SUBJECT: PLANS AND PROPOSAL ADDENDUMS
PROJECT: STP 2023 (675)MM CONTROL: 1433-02-044
COUNTY: COMAL
LETTING: 05/04/2023
REFERENCE NO: 0419

PROPOSAL ADDENDUMS

DESCRIPTION OF ABOVE CHANGES
(INCLUDING PLANS SHEET CHANGES)

8493-01UTL06-BGE.dgn
4/19/2023

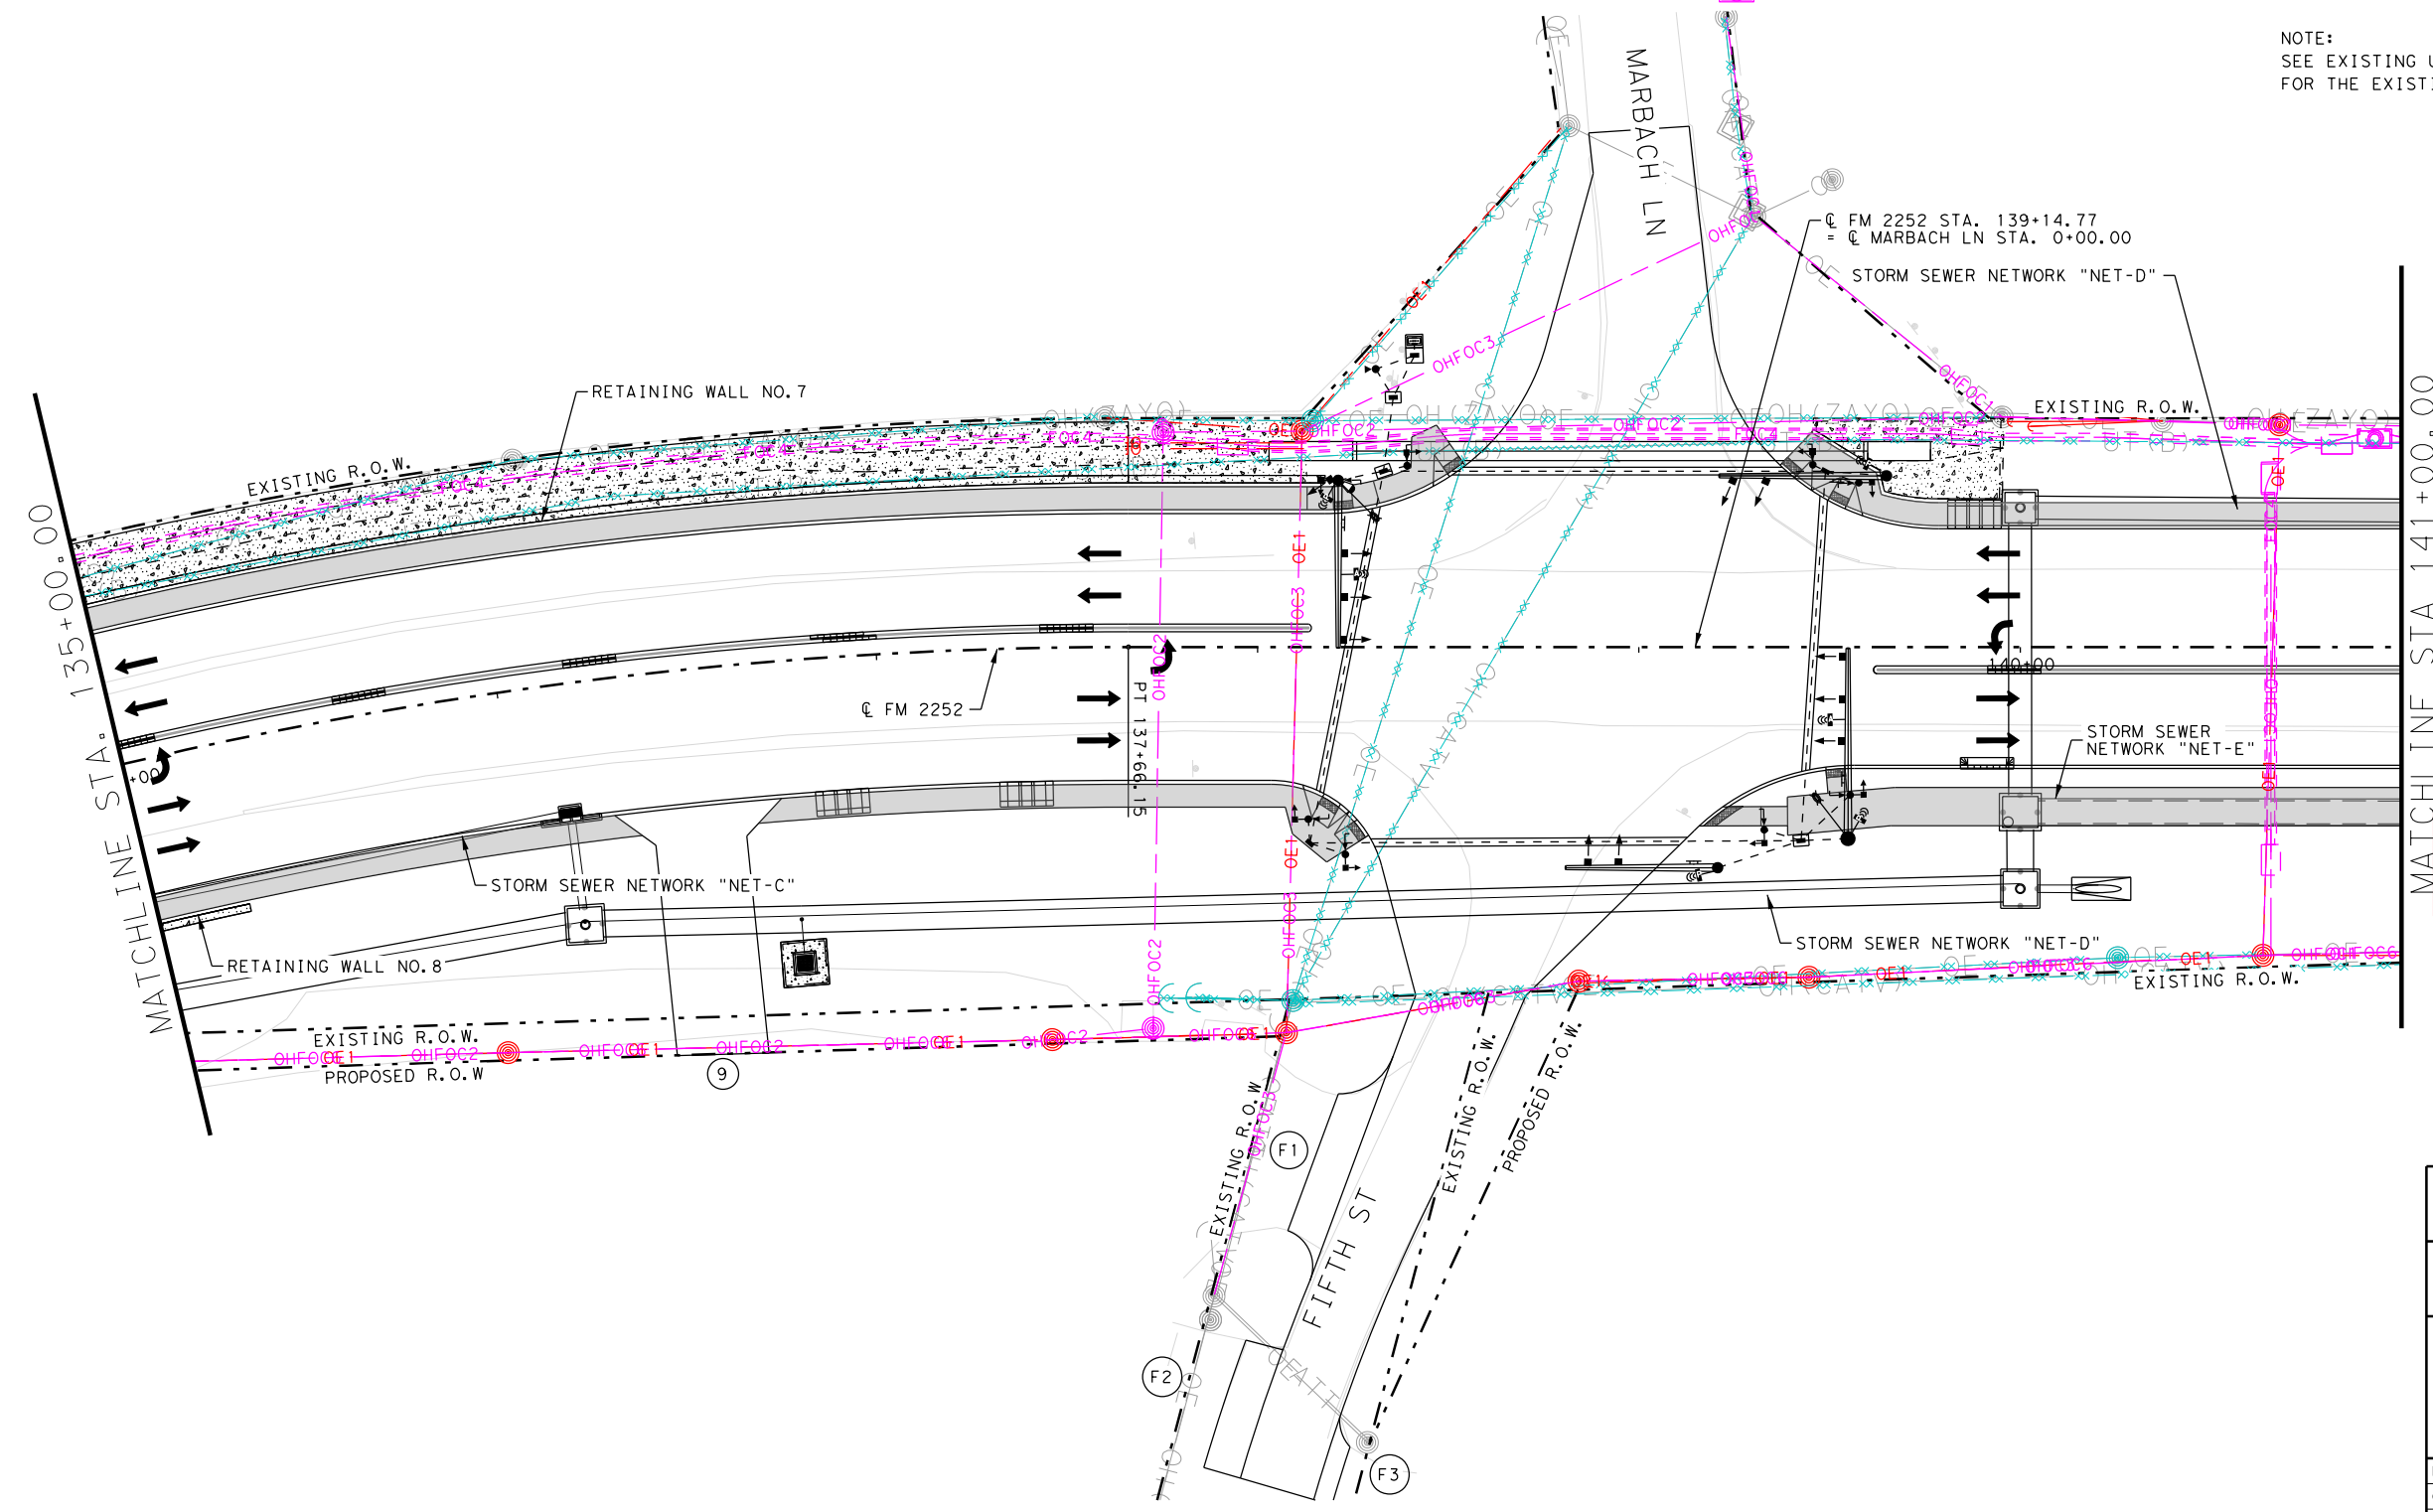
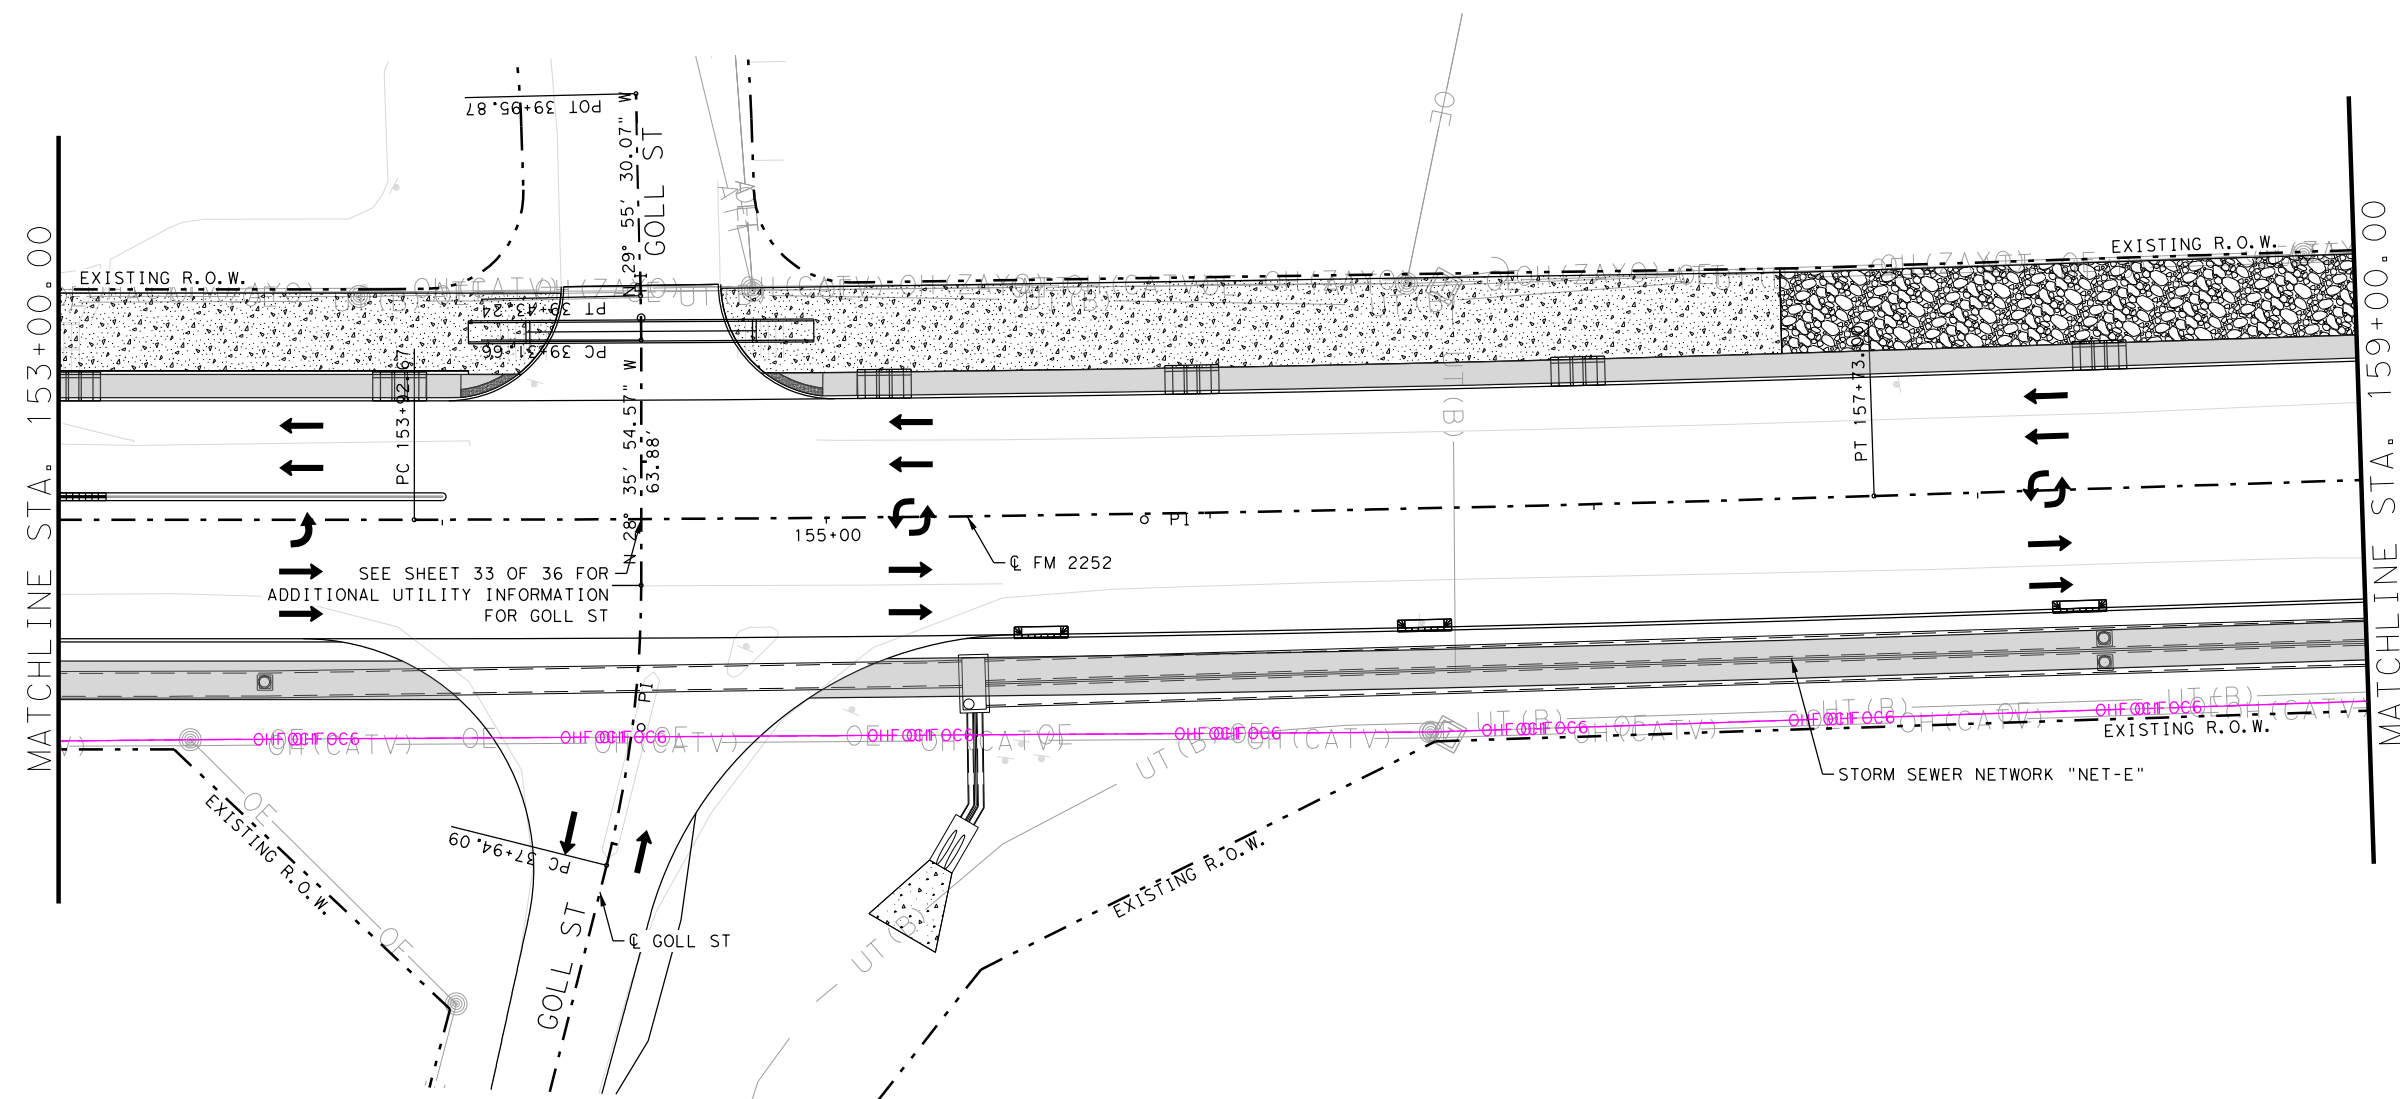
SHEETS 1330-1365: UPDATED UTILITY PLANS SHEETS LAYOUTS WITH CURRENT GAS
